TOWN OF GRAFTON, VT CAMBRIDGEPORT BRIDGE

PROPOSED IMPROVEMENT BRIDGE PROJECT COUNTY OF WINDHAM VT ROUTE 121, BRIDGE NO. 16G

RECORD PLANS	
CONTRACTOR:	F.W. WHITCOMB CONSTRUCTION CORP. - WALPOLE, NH
RESIDENT ENGINEER:	CHAD GREENWOOD
CONSTRUCTION BEGAN:	APRIL 11, 2006
CONSTRUCTION COMPLETE:	MAY 11, 2007
RECORD PLANS BY:	CHAD GREENWOOD & AMOS KEMPTON
I HEREBY CERTIFY THAT ALL THE CONSTRUCTION REQUIRED BY THIS SET OF DRAWINGS HAS BEEN ACCOMPLISHED AS INDICATED HEREIN.	
BY:	RESIDENT ENGINEER
DATE:	1/23/12
NOTE: Any further information concerning final quantities, amounts or other details relative to this project may be found at Central Files in the electronic archives.

THIS SHEET SUPERSEDES CONTRACT PLAN SHEET 1 DATED 6/05. REVISIONS ON THIS SHEET REFLECT CHANGES IN DESIGN AND DETAILS AS PER CHANGE ORDER NO. 2, SUBSTITUTING NEW STEEL BEAMS FOR RECYCLED BEAMS.

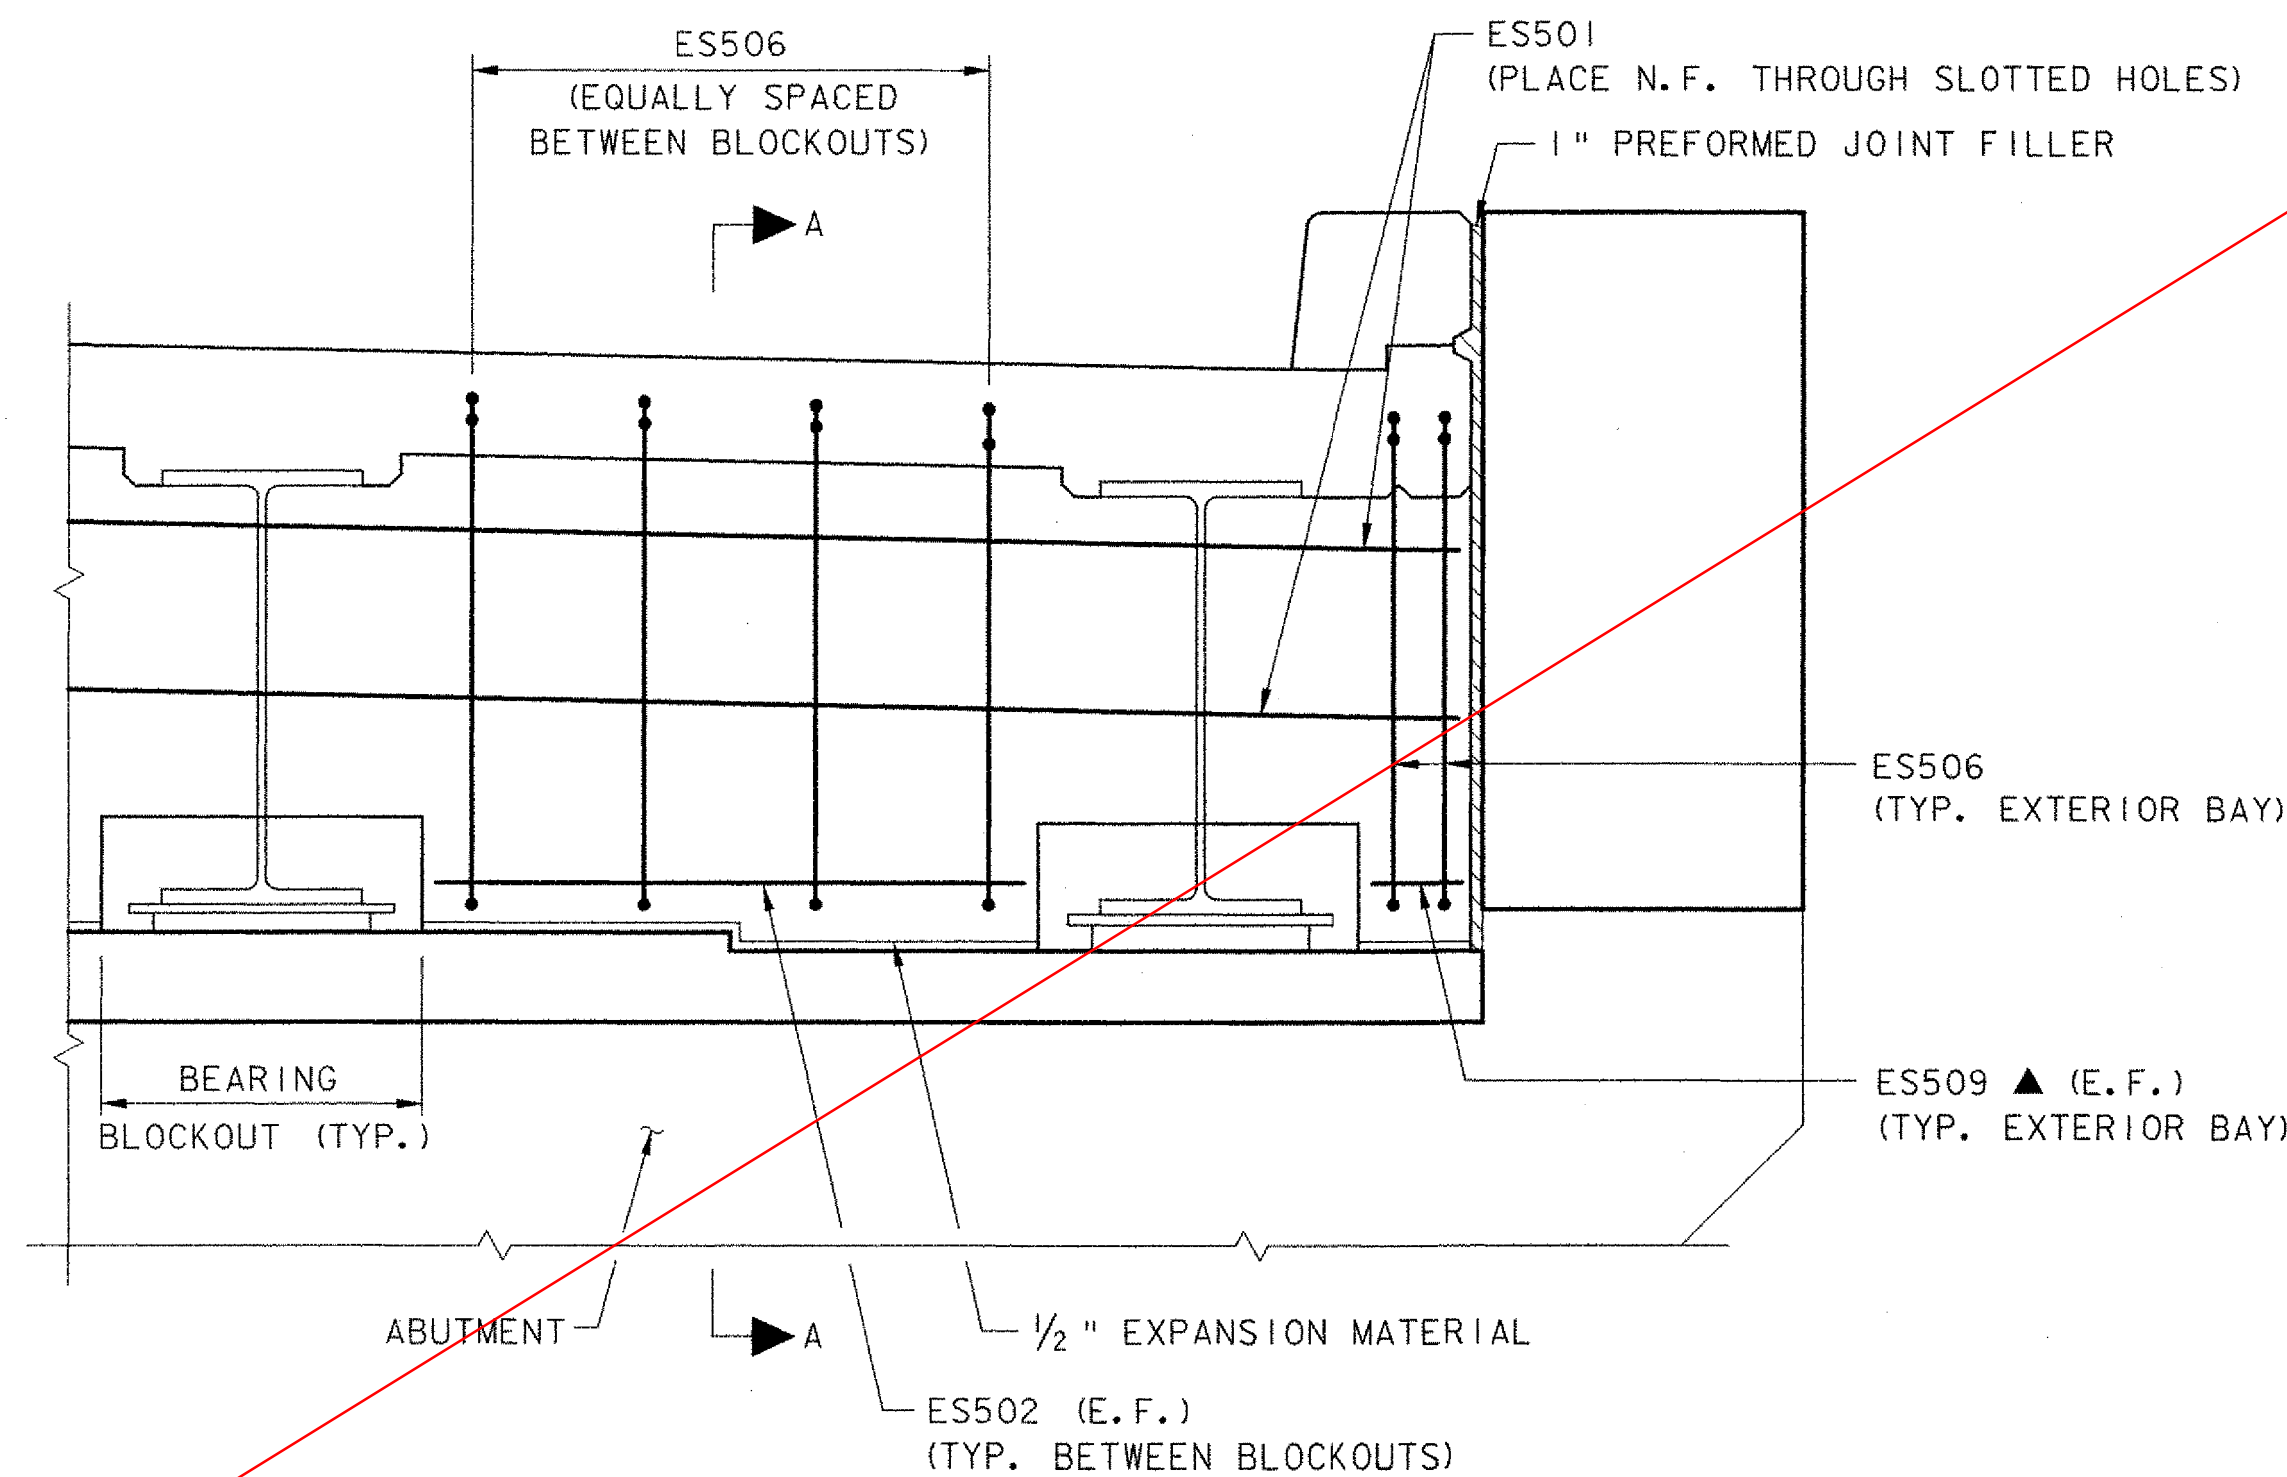
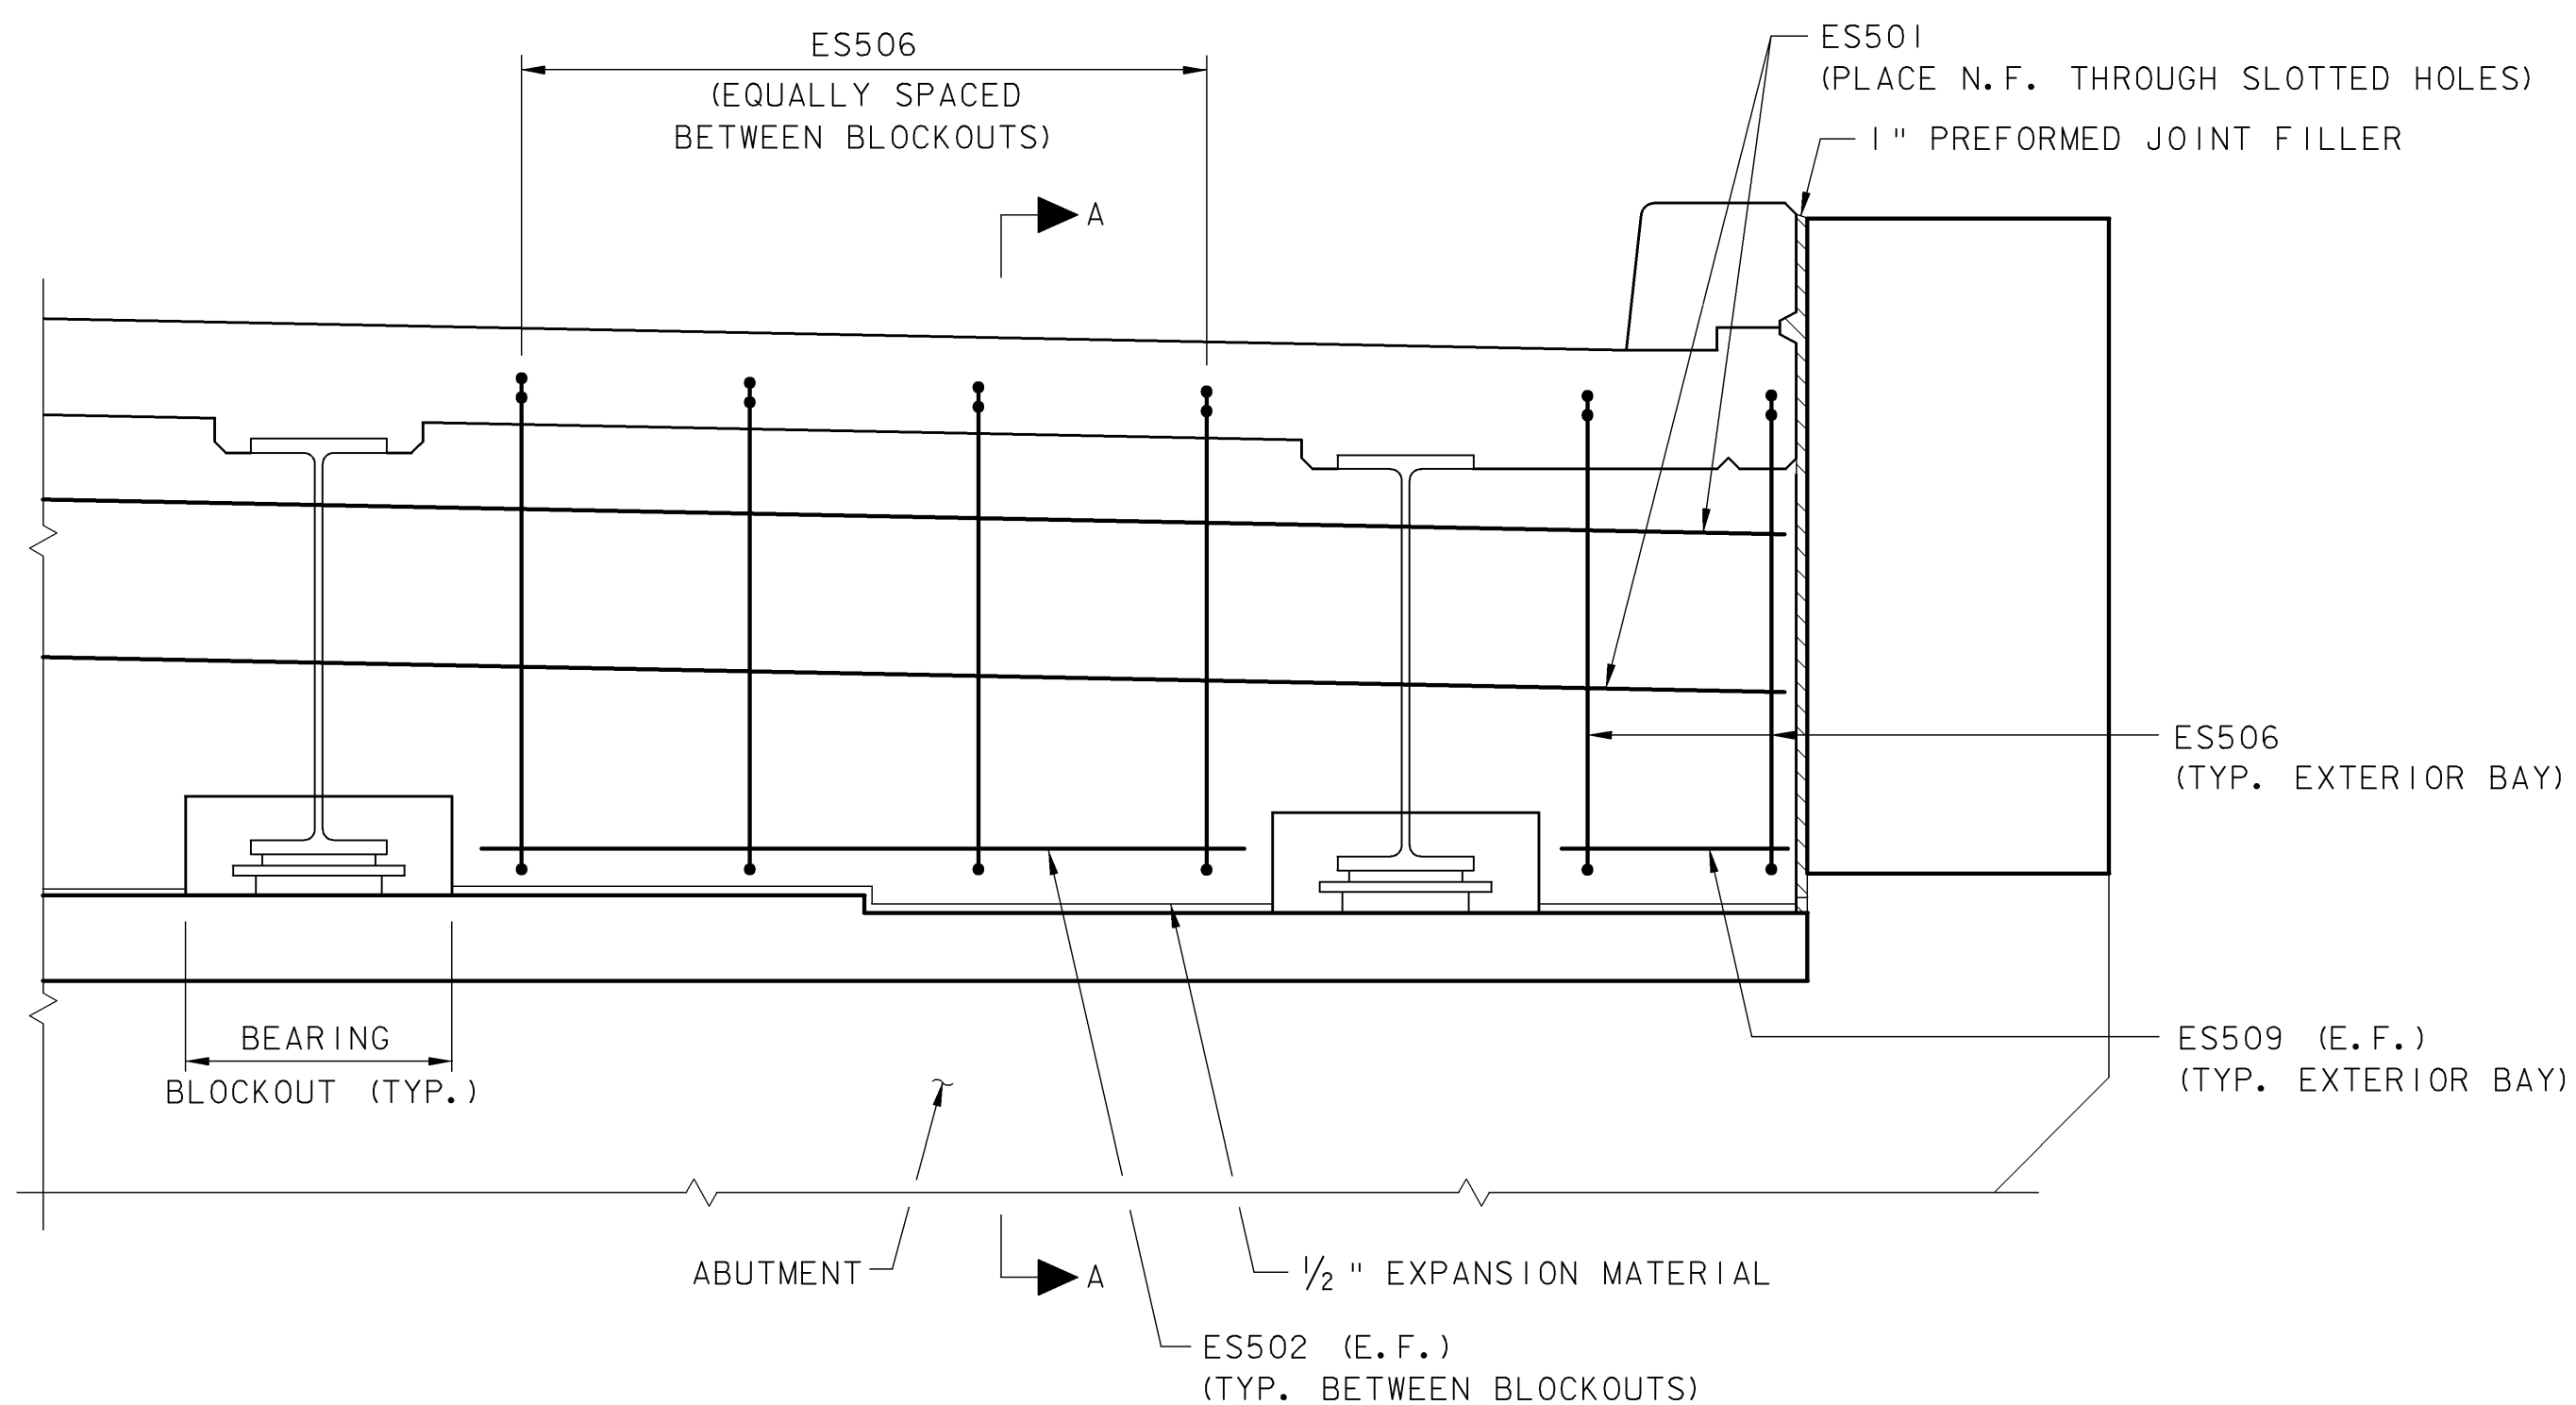
THIS SHEET SUPERSEDES CONTRACT PLAN SHEET 29 DATED 6/05. REVISIONS ON THIS SHEET REFLECT CHANGES IN DESIGN AND DETAILS AS PER CHANGE ORDER NO. 2, SUBSTITUTING NEW STEEL BEAMS FOR RECYCLED BEAMS.

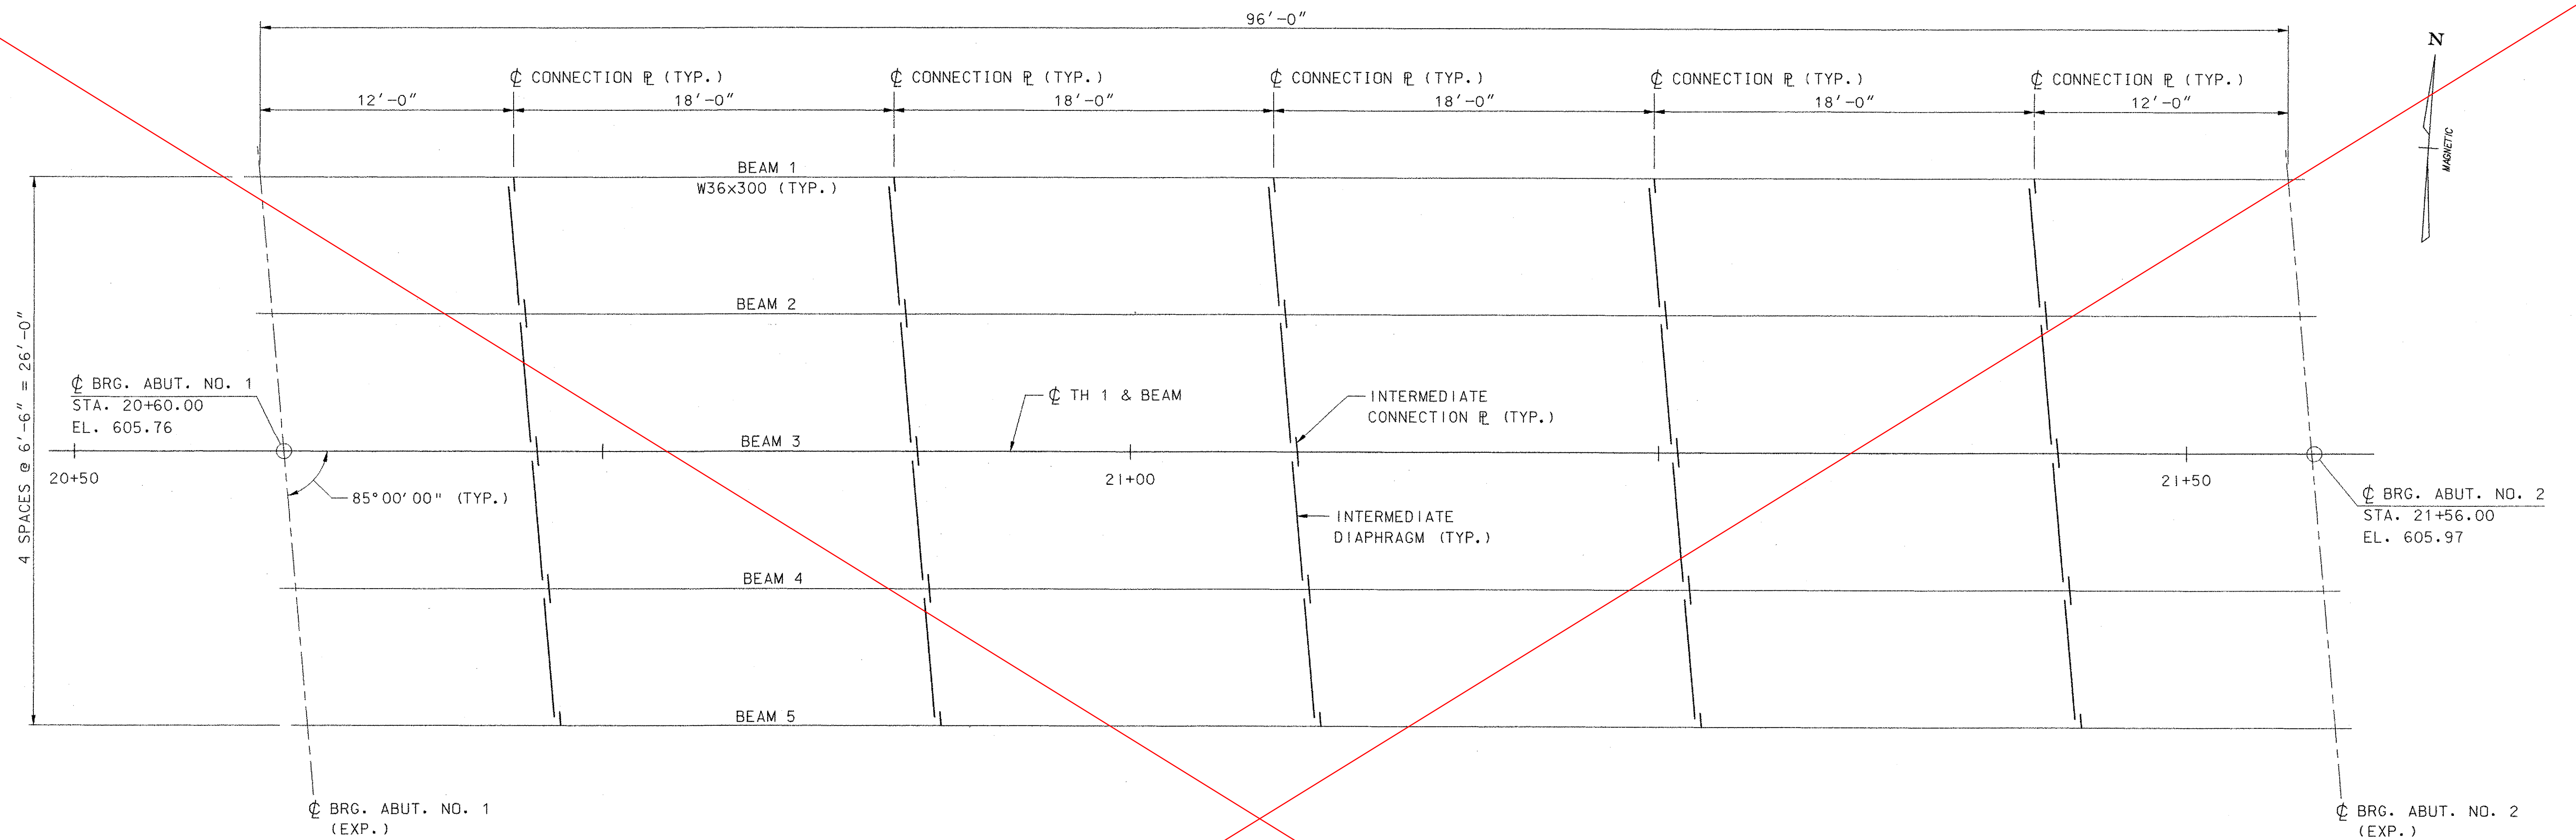
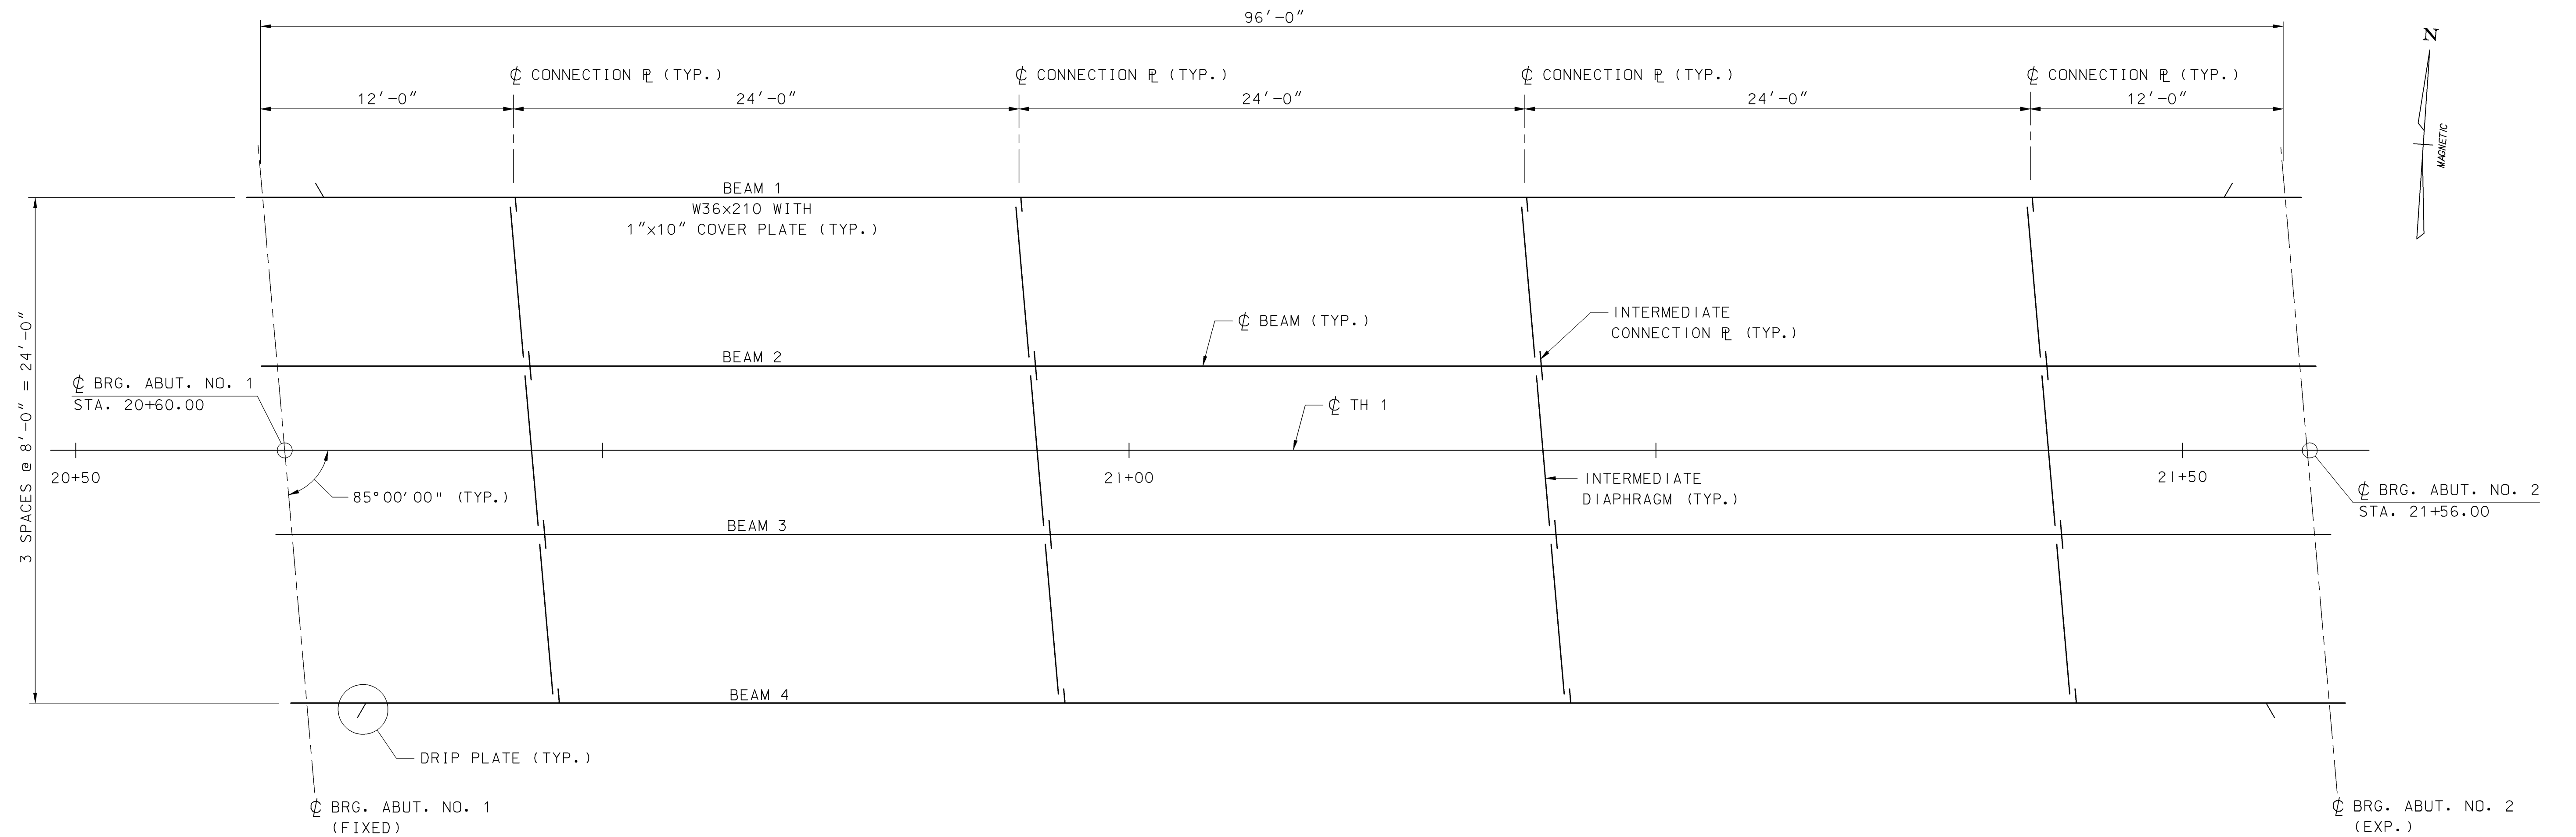
THIS SHEET SUPERSEDES CONTRACT PLAN SHEET 30 DATED 6/05. REVISIONS ON THIS SHEET REFLECT CHANGES IN DESIGN AND DETAILS AS PER CHANGE ORDER NO. 2, SUBSTITUTING NEW STEEL BEAMS FOR RECYCLED BEAMS.
